Report to the Future Melbourne (Planning) Committee

**Ministerial Planning Referral: TPM-2018-21
611-669 Elizabeth Street, Melbourne**

2 April 2019

DRAWING NO. **TP116**

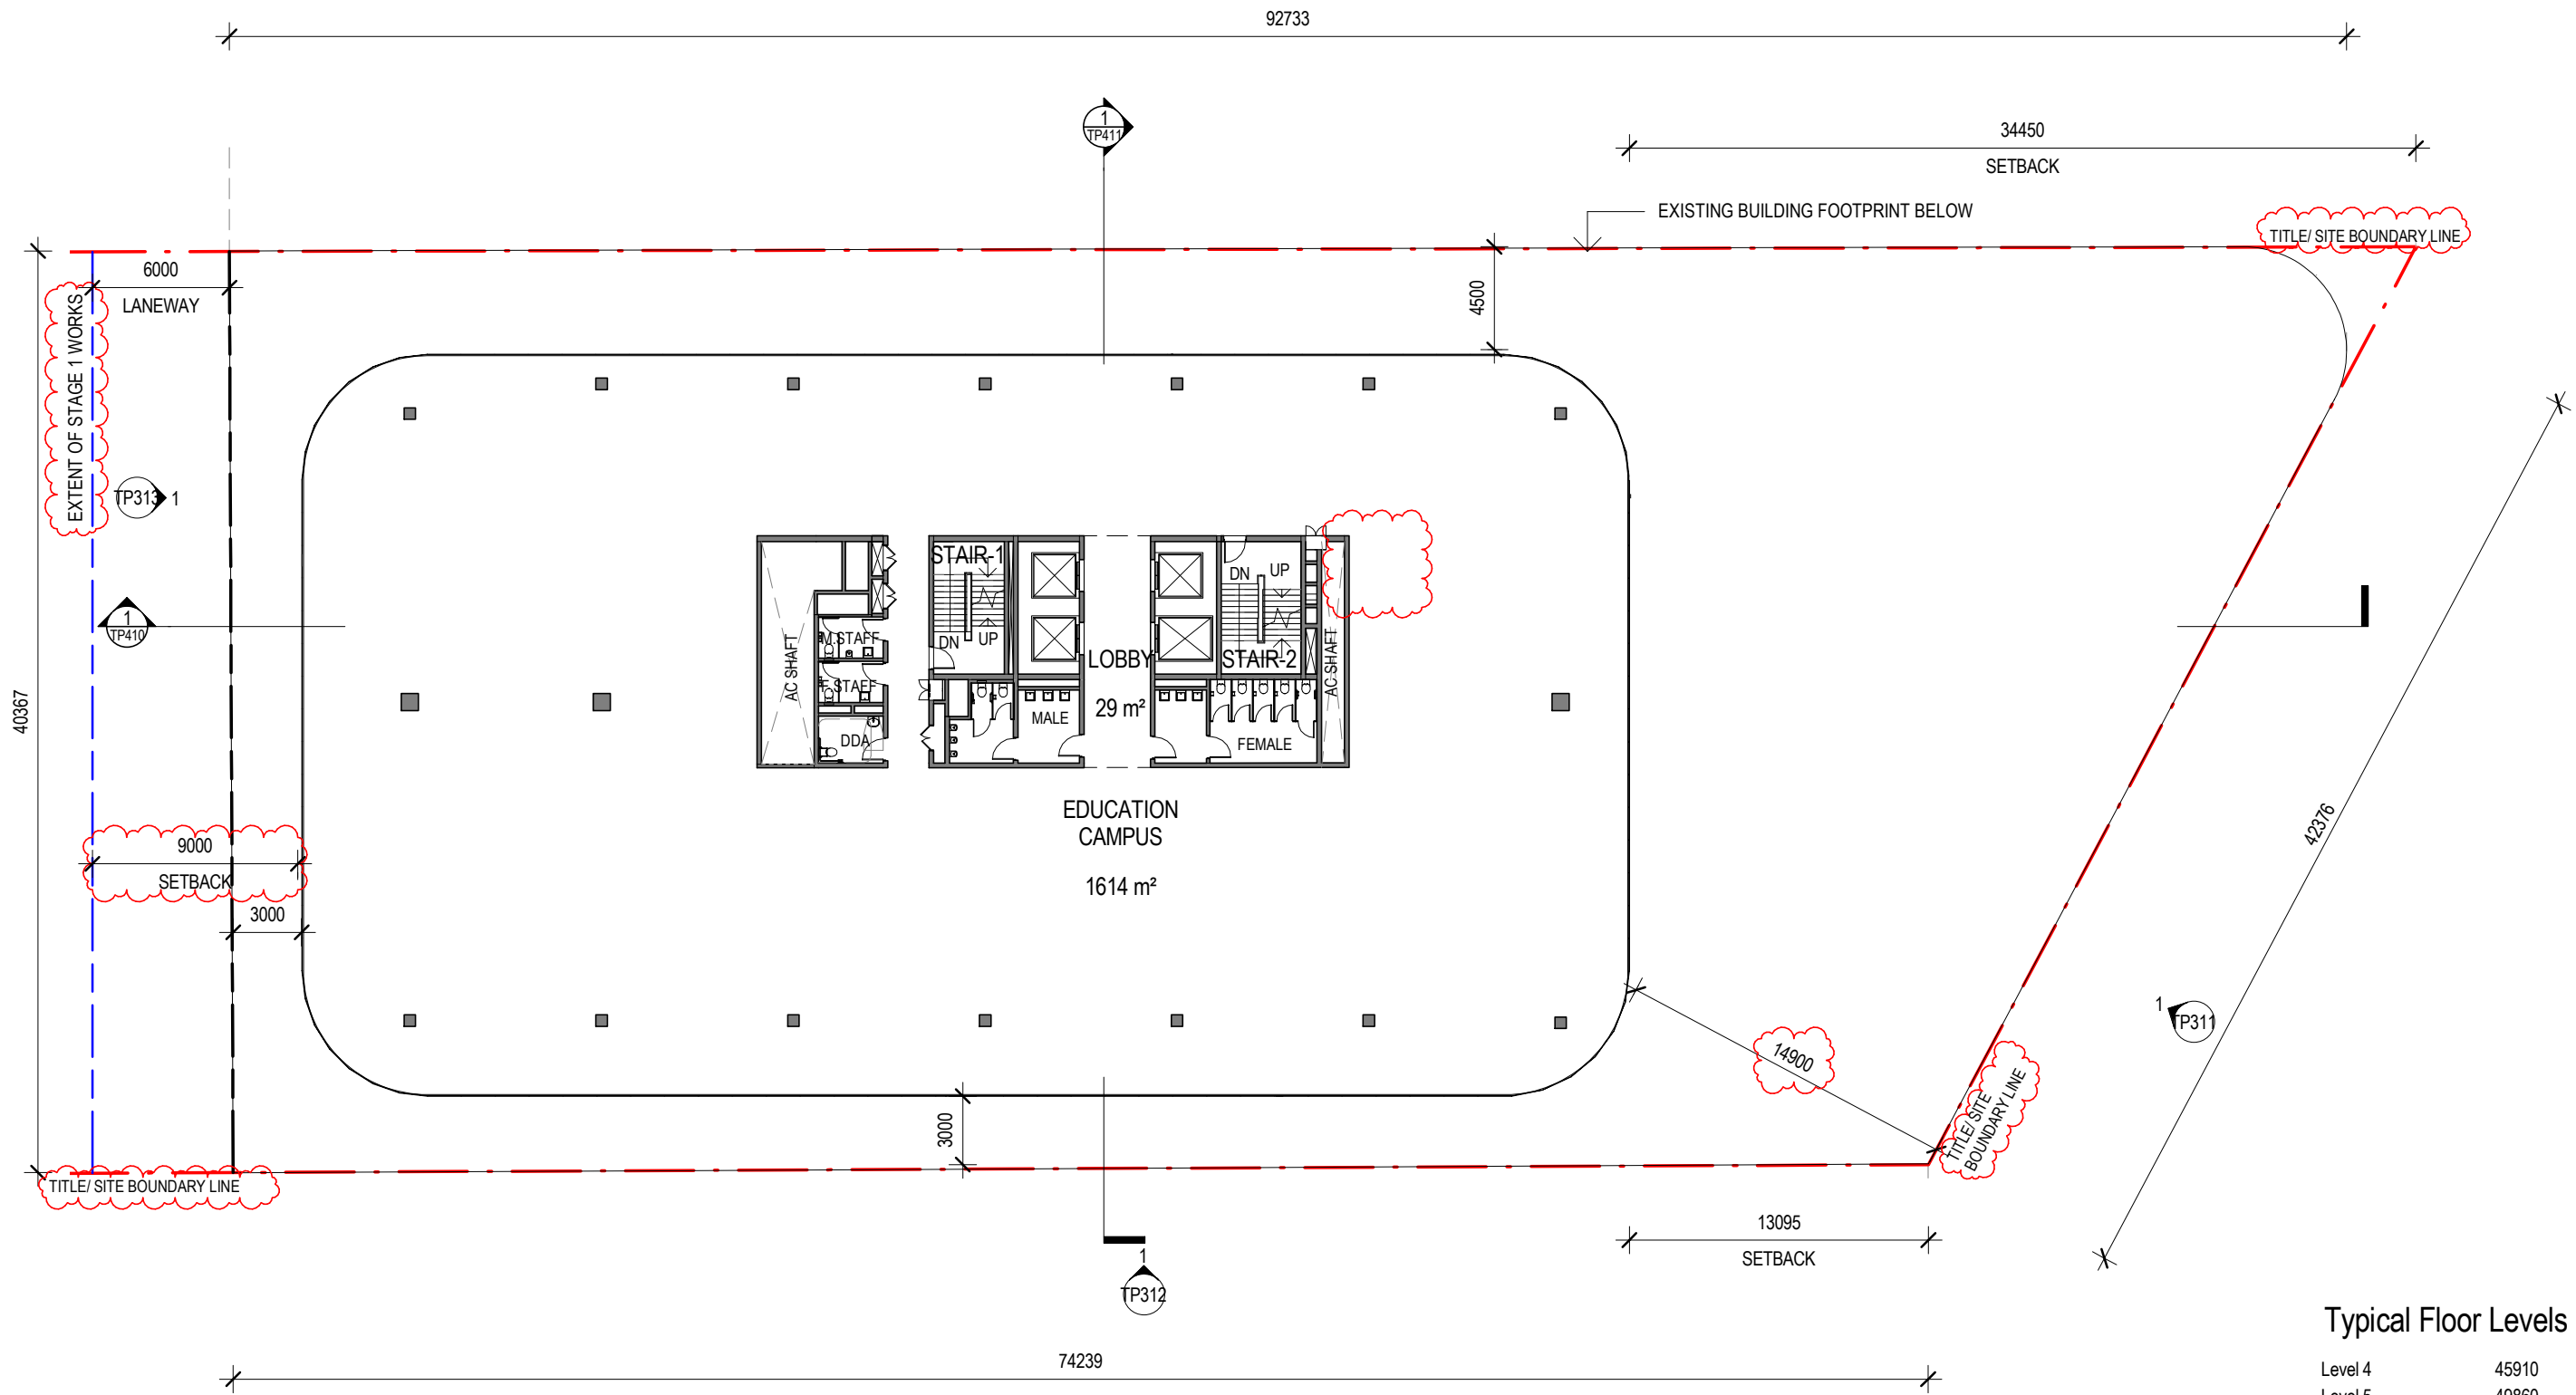
The proposal currently does not contain sufficient information to determine the long-term efficacy of the landscaping elements on the Level 3 podium annotated on plan TP116 as roof garden terrace for trees. It is recommended that a complete Landscape Plan, Landscape Maintenance Plan and Irrigation Performance Specification to be submitted to the satisfaction of Council.

The detailed landscape plans should include detailed schedules of species with specific consideration given to the suitability of selected species for the volume of planter or growing medium proposed. The Landscape Maintenance Plan should provide further detail with respect to ongoing maintenance of on-structure planters, including provision for maintenance beyond the fifty two week period following Practical Completion.

Response: Noted by applicant.

DRAWING NO. **TP118**

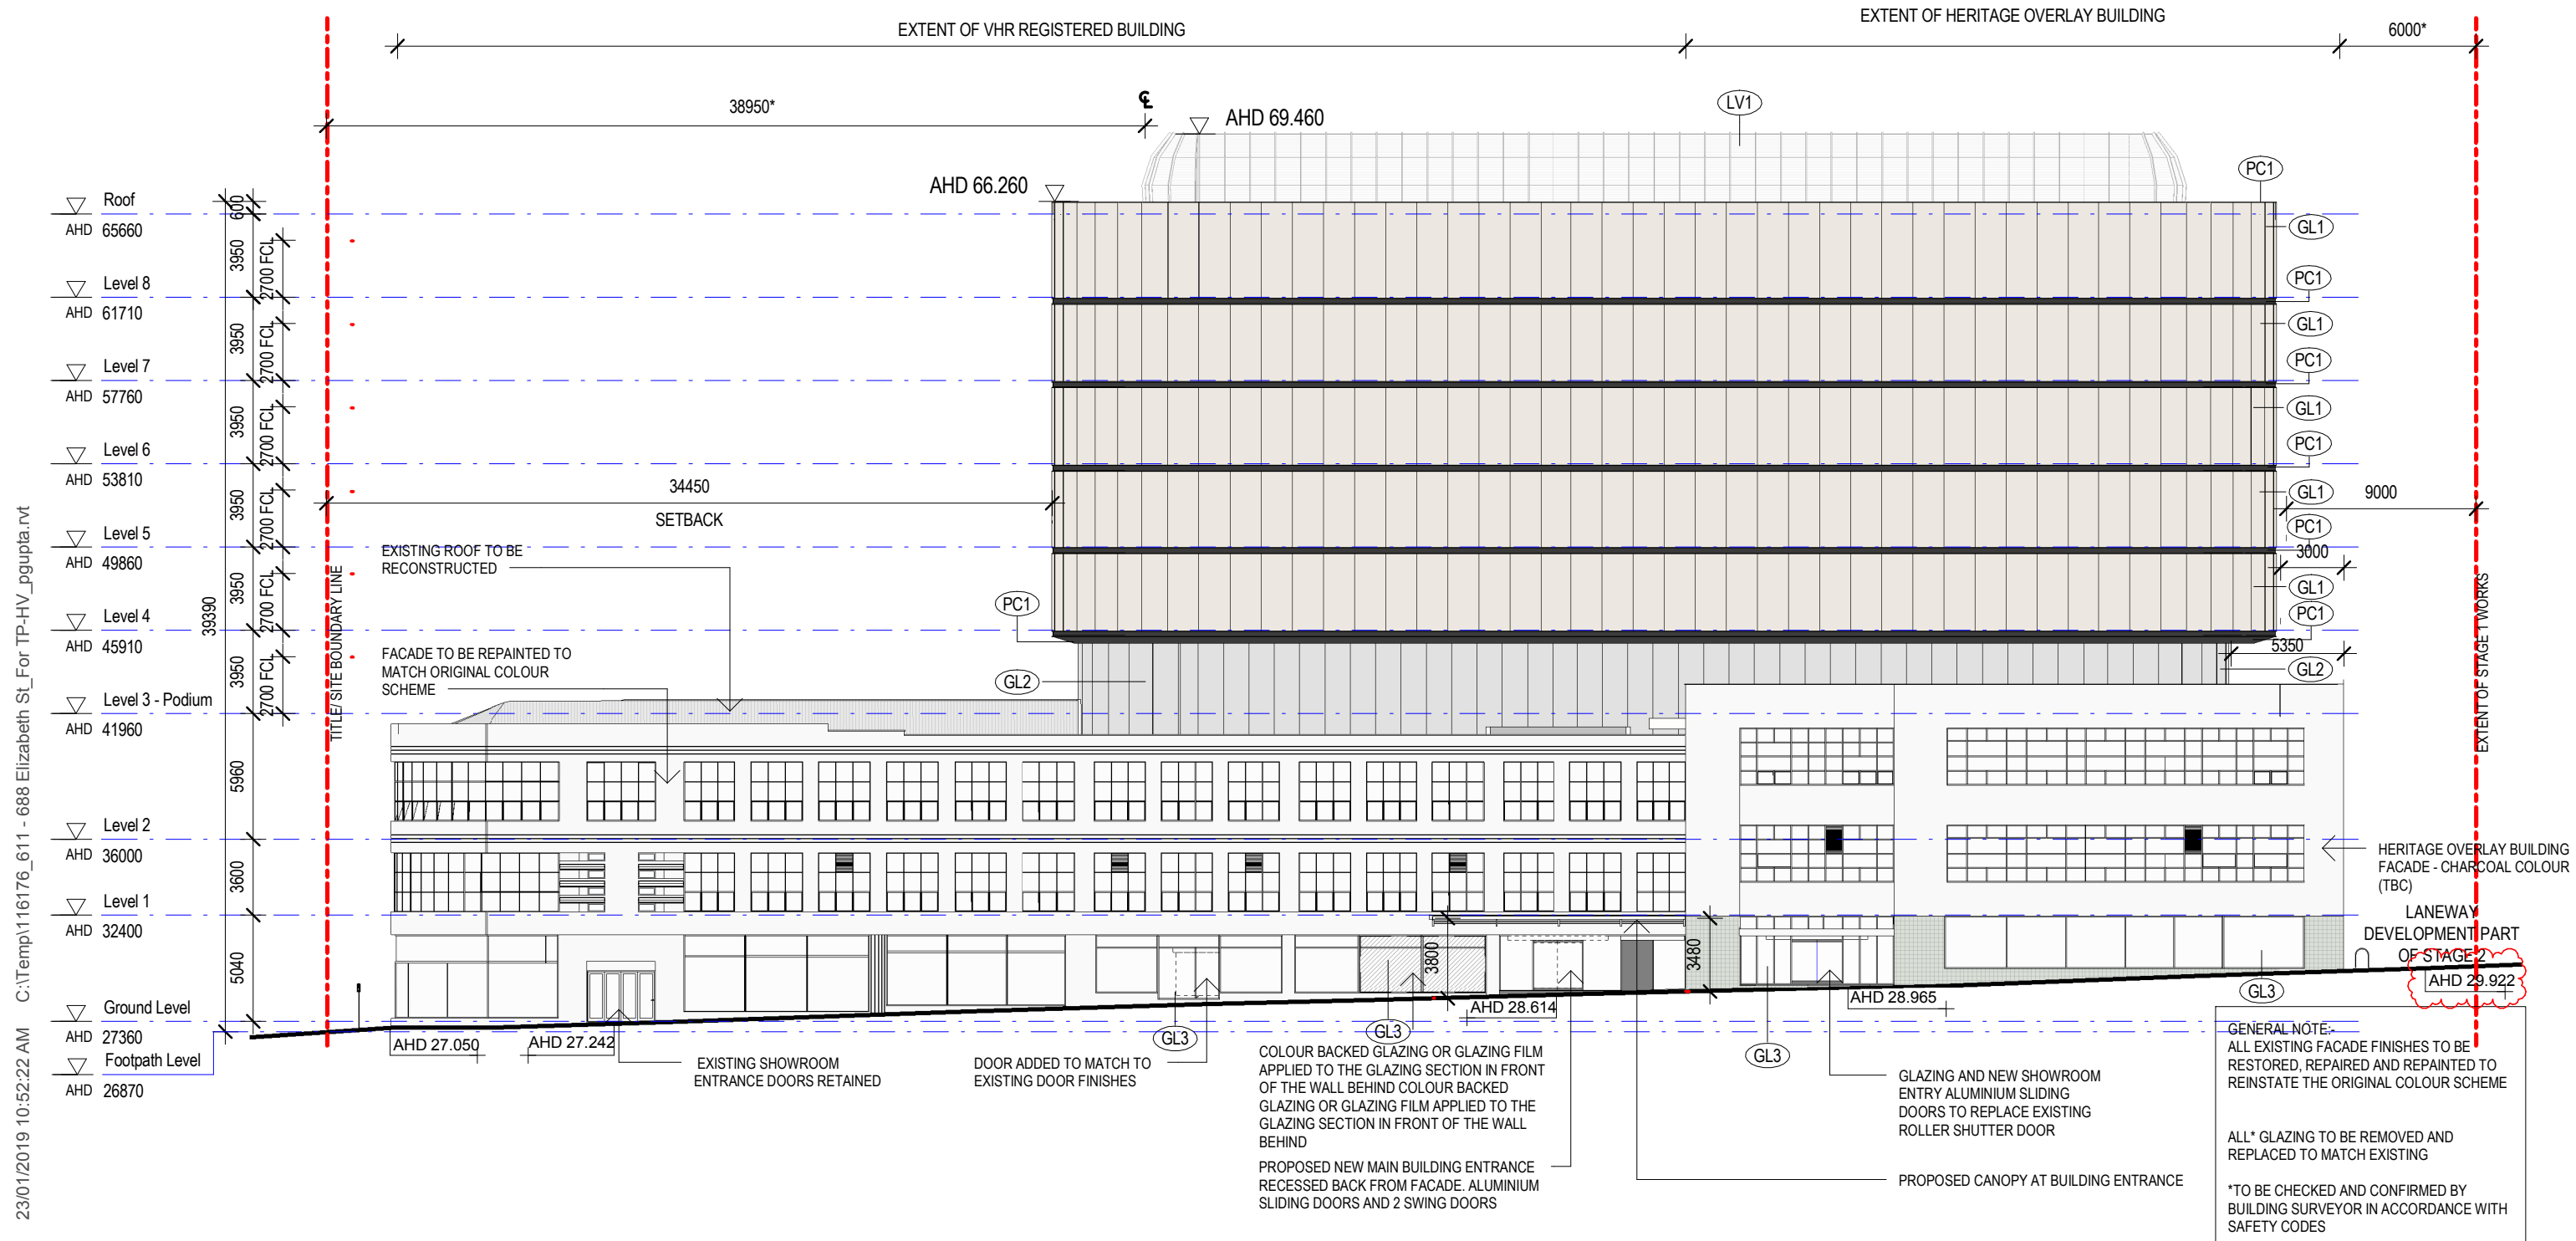
- **Building cap and plant** - prior comments remain. We do not believe that a setback of 4.5 metres from the edge of the roof parapet is sufficient in terms of mitigating the visual impact of the building cap due to the relative width of Elizabeth Street, Queensberry Street and the building prominence in the round.

Roof Plan, Source; Application documentation

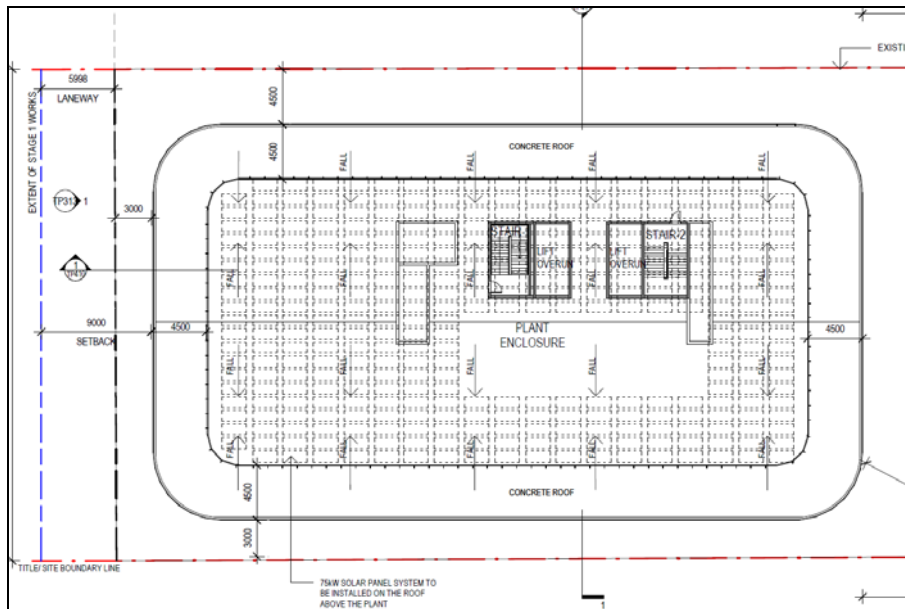
<p>Assessment: Complies.</p> <p>As detailed in the assessment of the proposed development against Local Planning Policy Clause 22.05 (Heritage Places outside the Capital City Zone), and the requirements of Table 1 of Schedule 61 to the Design and Development Overlay, it is considered that the height, massing, setbacks and architectural treatment of the proposed development achieve a balanced outcome, demonstrating proper respect for the retained historic buildings on-site, the vertical rhythm of emerging development along Elizabeth Street and a modified setback to Elizabeth and O'Connell Streets which will assist with strengthening the street edge without being overbearing to the heritage host.</p>	
<p>Building Facades and Street Frontages</p> <p>To ensure that buildings are well designed and enhance the amenity of City North.</p> <p>To deliver a fine grain built form with architectural variety and interest.</p> <p>To encourage high quality facade and architectural detailing.</p>	<p>Addressing the Street</p> <p>The articulation of building facades should express a fine grain. Expressing the vertical elements is encouraged to minimise the dominance of wide building frontages.</p> <p>Multiple doors / entrances to buildings and windows should be provided off the street to improve activation of the street.</p> <p>The facades of buildings should maintain the continuity, and traditional characteristic vertical rhythm of streetscapes.</p> <p>All visible sides of a building should be fully designed and appropriately articulated and provide visual interest.</p> <p>Blank building walls that are visible from streets and public spaces should be avoided.</p> <p>Buildings on corner sites should address both street frontages.</p> <p>Service areas</p> <p>Service areas (plant, exhaust, intake vents and other technical equipment and other utility requirements) should be treated as an integral part of the overall building design and visually screened from public areas.</p>

<p>Buildings should be designed to integrate attachments (including antennae) without disrupting the appearance of the building.</p> <p>Building Projections</p> <p>Building projections outside the property boundary should accord with Council’s Road Encroachment Guidelines.</p>
<p>Assessment: Complies.</p> <p>The City of Melbourne’s Urban Design team have reviewed the proposal and have raised several issues with the design of the proposed tower. Specifically the following has been noted:</p> <p>...the fundamental issue of massing and character of the tower form still remains. We acknowledge that Heritage Victoria have provided support regarding the application and have subsequently issued a permit, however we do not believe the proposal provides a satisfactory outcome for the host building, the streetscape nor the broader precinct of which the building is a part. We note that Gray Puksand have undertaken some design testing regarding the expression of the upper form, however we believe the resultant form does not reflect the expected level of design quality for a tower of this prominence and significance. We recommend further design exploration of the tower form, articulation and expression prior to recommending approval, noting that previous iterations explored by Gray Puksand were ill-favoured by Heritage Victoria.</p> <p>In regard to the expression of the tower the following comments have been made:</p> <p>As the building is highly exposed to broad streets and is viewed in the round, we are concerned about the lack of a clear architectural identity. While we understand the general principle of a ‘neutral backdrop’ for well recessed ‘lantern’ elements atop of heritage, the proposal is more than double the height of the base and has a significant urban presence. The proposed flat curtain wall approach tower does not thoughtfully respond to cues such as rhythm, depth and detail within the Harry Norris building, or the broader context.</p> <p>... Provide meaningful articulation of the tower that relates to the scale of the Harry Norris building. Utilise balconies or breakout spaces to create deliberate openings or moments to connect the tower to the streetscape. Explore expression of the columns through the glazing to avoid the appearance of a ‘floating’ form atop the host building.</p> <p>While it is acknowledged that the proposed tower may be considered acceptable from a heritage perspective it is also important to ensure that buildings on prominent sites are designed to achieve a high standard of design which reflects the importance of their location and extent of their visibility as required by relevant Urban Design policy.</p> <p>Having regard to the above, from an Urban Design perspective, the design of the proposed tower is not considered to appropriately meet the design objectives outlined in Table 2 of DDO61 which seeks to (amongst other things) to ‘encourage high quality facade and architectural detailing.’ As such a condition of permit will recommend that further work be undertaken between the applicant, DELWP and City of Melbourne to further evolve the façade design of the tower to ensure the delivery of a textured, modulated upper form that incorporates meaningful articulation and sits comfortably within this important boulevard location.</p> <p>In regard to the services on the roof of the building the proposal has been designed to incorporate plant screening set back from the edge of the parapet (4.5 metres setback to edge of building) in the form of a louvre plant screen as highlighted in the roof plan below.</p> <p>The City of Melbourne’s Urban Design team has raised concern with the current plant screening and recommended the plant enclosure be integrated into the parapet to avoid a secondary massing element on top of the building. The detail of this screen may need to be evolved with any façade update and a condition of permit will be recommended allowing this to occur.</p>

Summary of ground level wind conditions for the proposed configuration, Source: MEL Consultants, January 2019

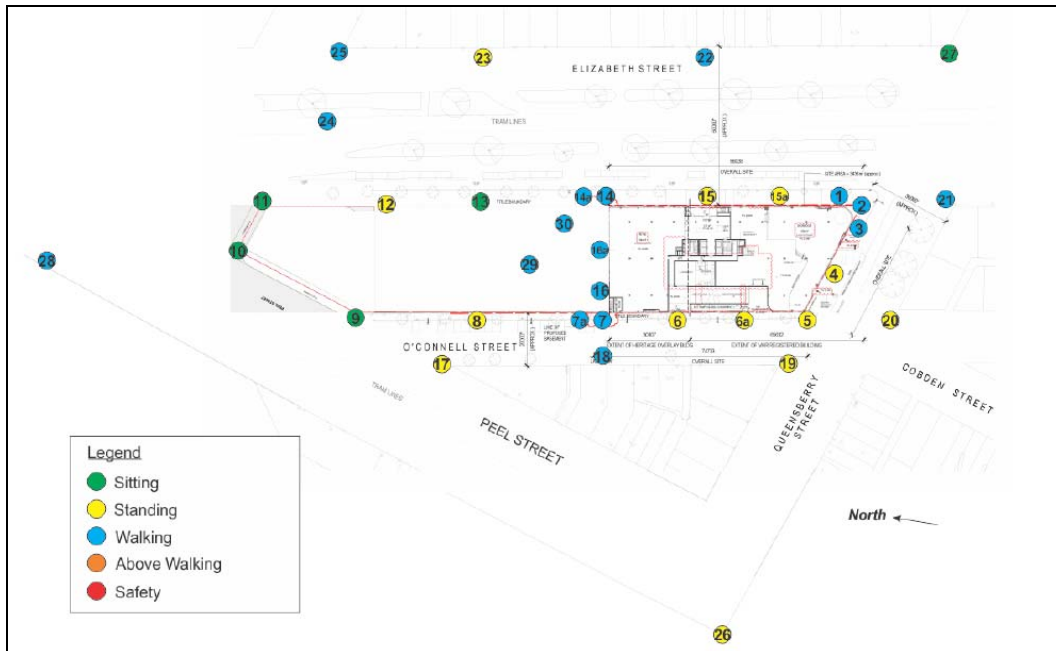
The Wind Impact Assessment has identified that three areas at the corner of Elizabeth and Queensberry Streets will only reach Walking Criteria and test points 1, 2 and 3 and at test points 14 and 14a along Elizabeth Street at the entrance to the proposed laneway. While it is acknowledged that test point 2 currently only meets walking criterion it is considered appropriate to recommend a condition on any permit that will require further details to be provided within a revised Wind Impact Assessment to highlight how the Major Pedestrian routes will be treated to ensure compliance with the requirements of DDO61.
